Application Report

**Planning, Housing and Health
North Devon Council
Lynton House, Commercial Road,
Barnstaple, EX31 1DG**

Application No:	76784
Application Type:	NDC Regulation 3
Application Expiry:	8 March 2024
Extension of Time Expiry:	8 March 2024
Publicity Expiry:	20 December 2023
Parish/Ward:	TAWSTOCK/ROUNDSWELL
Location:	North Devon Leisure Centre Seven Brethren Bank Barnstaple Devon EX31 2AP
Proposal:	Reserved matters application under Regulation 3 of the T & C P General Regulations 1992 notification by NDC pursuant of the outline application of 73606 - Outline application for 180 dwellings together with all associated infrastructure) (amended plans/documents)
Agent:	Mr Stephen Bain
Applicant:	Mr James Brent
Planning Case Officer:	Mrs J. Meakins
Departure:	N
EIA Development:	
EIA Conclusion:	Development is outside the scope of the Regulations.
Decision Level/Reason for Report to Committee (If Applicable):	Committee The land is owned by North Devon Council

Block Y & Z Street Elevation - East
1 : 200

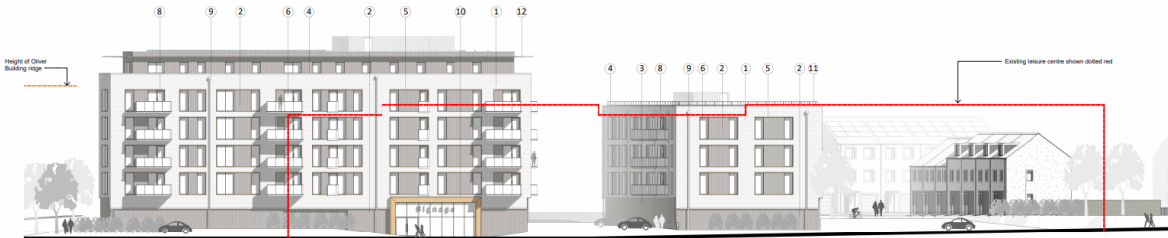
Name	Comment
	<p>attention to design shown with the redevelopment of land at Riversvale, Litchdon Street on the opposite side of the river.</p> <p>In further detail, Block Y and Z are particularly dominant and of an uncompromising design that has little or no regard to the site's context. The proposed areas of 'pre- fabricated cladding' at street level will be prominent in the public domain and the weak architectural detailing fails to respond positively to the site's context and the town's heritage and will result in the visually unattractive development of its prominent riverside site. In terms of the NPPF, the development is considered to be of poor design quality, unsympathetic to local character and the town's history and will not lead to a strong sense of place.</p> <p>A specific concern was raised in respect of the height of the proposed development, including Blocks Y and Z, and fire safety implications (have the emergency services been consulted?).</p> <p>Reasons for Refusal - Heritage.</p> <p>The following comments take into account the considerations set out in the applicant's Heritage Statement dated 14th. February 2023 which need to be read alongside the supporting text (paragraph 10.66) to Policy BAR13: Seven Brethren which states: 'The character and appearance of the adjacent conservation area and setting of the historic assets of Longbridge and Old Slaughterhouse (Halfords) will be protected under Policy ST15: Conserving Heritage Assets'.</p> <p>The above noted Heritage Statement for reasons that are unclear makes no reference to the most relevant Policy DM07: Historic Environment of the adopted North Devon and Torridge Local Plan. Furthermore, the conclusion set out in paragraph 7.3.1 '(the degree of impacts arising from proposed development are assessed to be of Negligible to Low Adverse Degree on the overall heritage significance of the heritage assets') does not appear to be evidence based and very clearly contradicts the informed views of the Council's Conservation Officer.</p> <p>The conclusion to The Heritage Statement states: 7.4.3 The current proposals do not offer any clear beneficial impacts to heritage assets. However, the proposed changes will not result in any identifiable detrimental effects to built heritage beyond those impacts identified in the original application, as summarised in Table 6.</p> <p>Such an outcome is directly contrary to the requirements of Policy ST15: Conserving Heritage Assets which requires development to preserve and enhance northern Devon's historic environment and also Policy DM07: Historic Environment which states: (2) Proposals which conserve and enhance heritage assets and their settings will be supported.</p>

<p>Heritage & Conservation Officer</p> <p>Reply Received 7 September 2023</p>	<p>I made detailed comments on this application in my initial response of 4.5.23. In that response, which still stands, I advised that blocks Y and Z would have the greatest impact on significance, through effect on settings, of the various designated heritage assets in the vicinity. There have been no changes to the design, siting or massing of blocks Y and Z, therefore my view that the proposal will cause less than substantial harm to the significance of these heritage assets through effects on setting still stands. Therefore under the provisions of paragraph 202 of the NPPF, the public benefits of the proposal will need to be weighed in the balance when the decision is made.</p> <p>I did comment in my initial response that it would be helpful if drawings which enabled the comparison of existing and proposed heights and massing could be provided. This has been done, on page 4 of the recent Planning Amendments document, and I think the illustration does prove the point about the increased impact that Block Y, in particular, will have on the immediate environs of the Long Bridge</p>

The apartment blocks (referred to as Blocks Y and Z in the submission) are arranged over 6 and 4 storeys respectively, with undercroft parking at ground floor level and living accommodation above. These stand on the site of the old Leisure Centre.
